American National Standard

AT Attachment with Packet Interface Extensions 5 (ATA/ATAPI-5)

Corrected:

In this erratum, pages 116,265, 266, 267, 268, 269, 270, 280,306,309,310,321, 380 and 382 are reprinted with corrections.

Figure 33 - Host PACKET DMA command state diagram

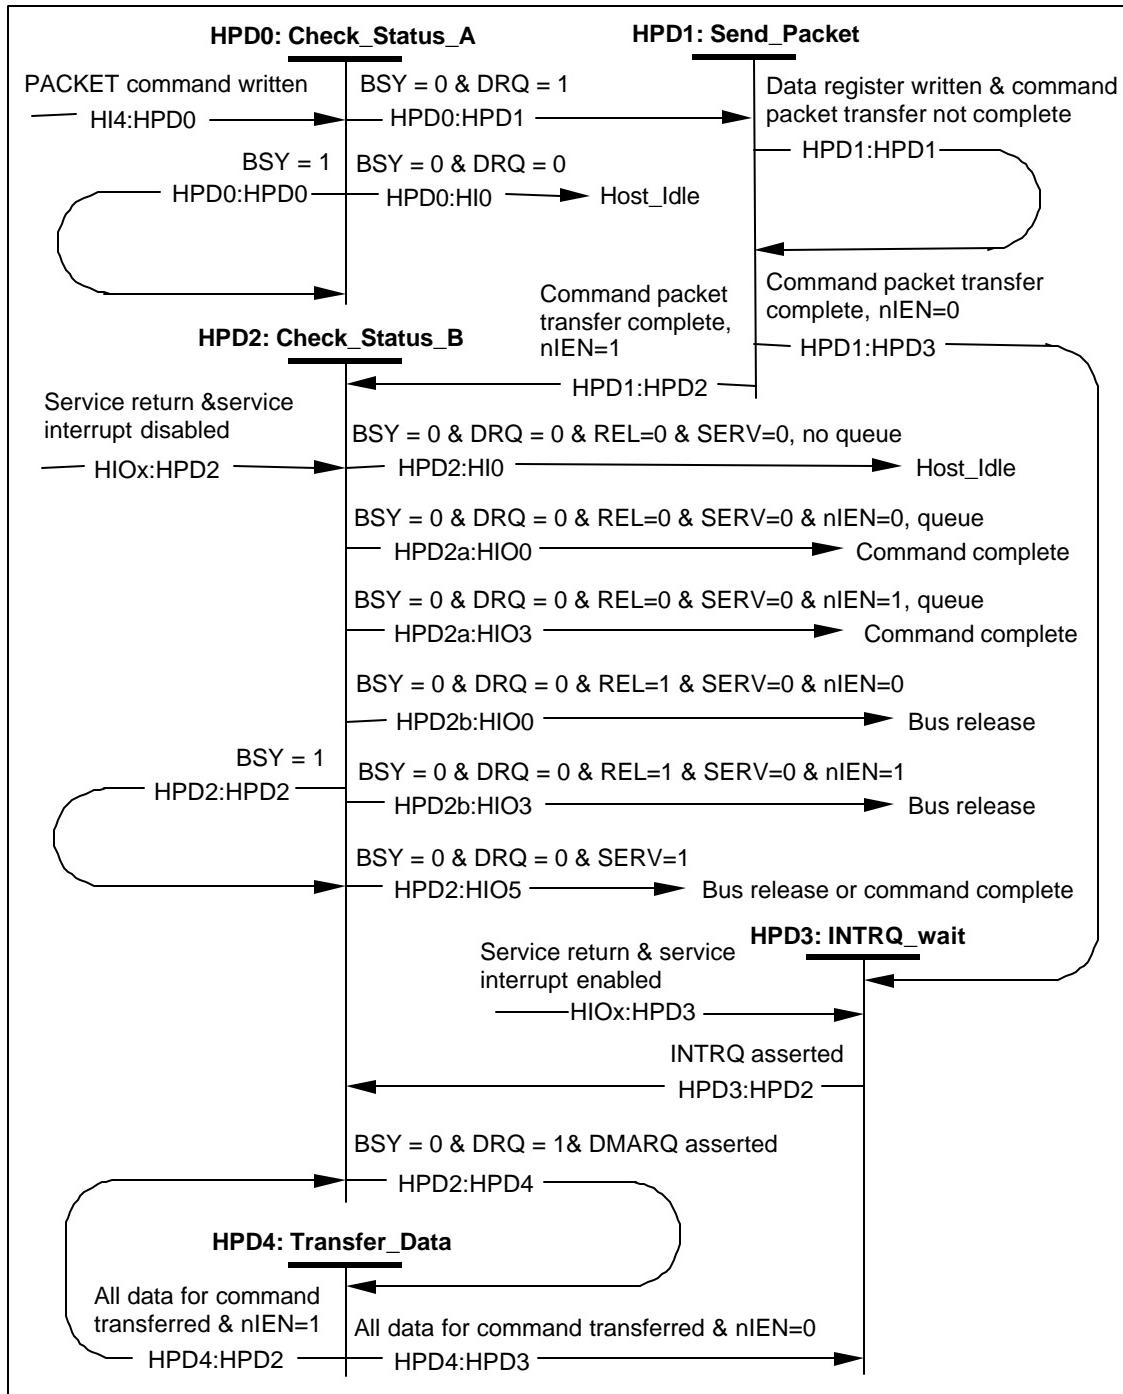
Page 265 through 270 of NCITS 340-2000 clause 9.8 was not properly converted from the flow charts in NCITS 317-1998 to the state diagrams. The state diagrams figures 33 and 34 and the associated text is modified to indicate that the device interrupts only at command completion.

Figure 54 – Initiating an Ultra DMA data-out burst

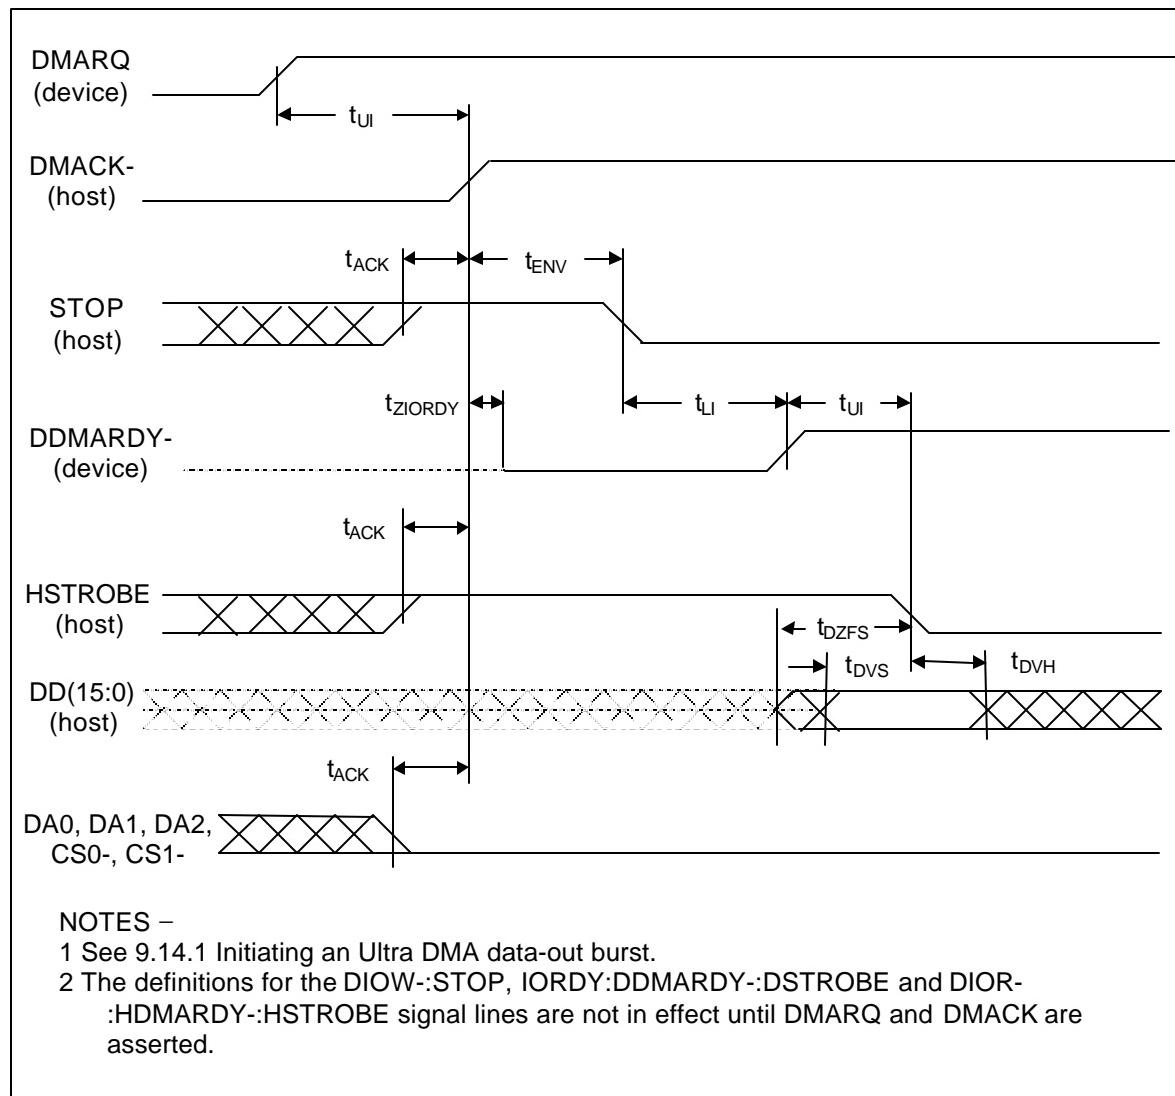
Page 306 of NCITS 340-2000 figure 54 the initial states shown for STOP and HSTROBE were incomplete and the released state of DDMARDY- was incorrect. The figure is corrected to represent the actual states.

Figure 57 – Host terminating an Ultra DMA data-out burst

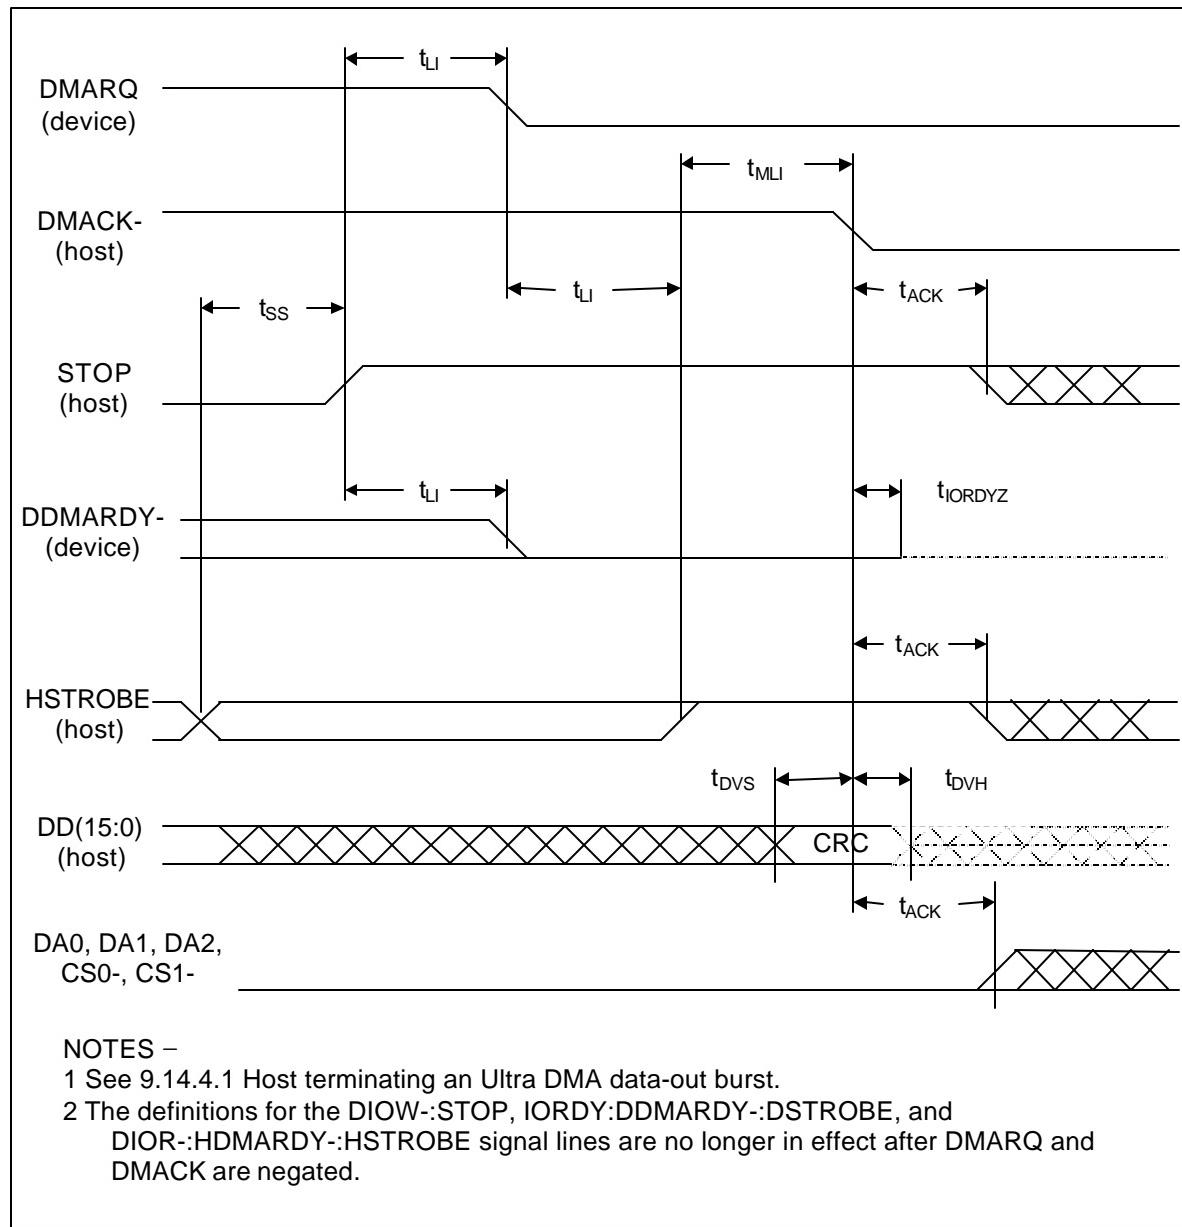
Page 309 and 310 of NCITS 340-2000 figures 57 and 58 the ending states shown for STOP and HSTROBE were incomplete and the released state of DDMARDY- was incorrect. The figure is corrected to represent the actual states.

Figure A.8 - Device 4-pin power header

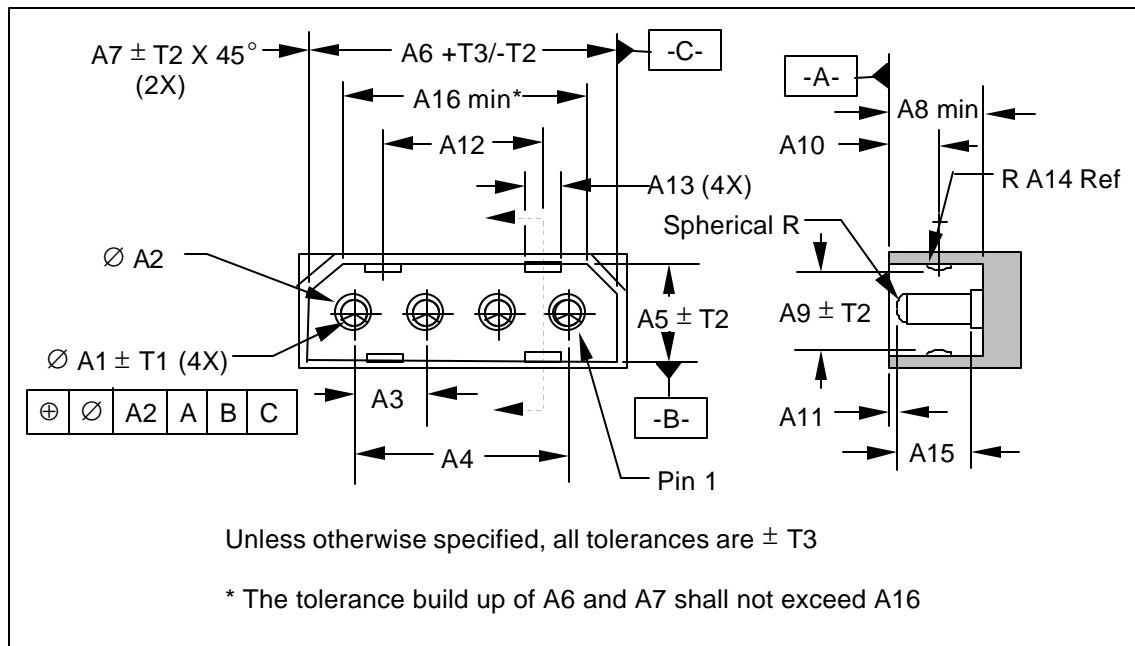
Page 321 of NCITS 340-2000 figure A.8 the dimension A8 is drawn from the top of the well to the detent the same as dimension A10. The figure is corrected to show dimension A8 from the top of the well to the bottom of the well.
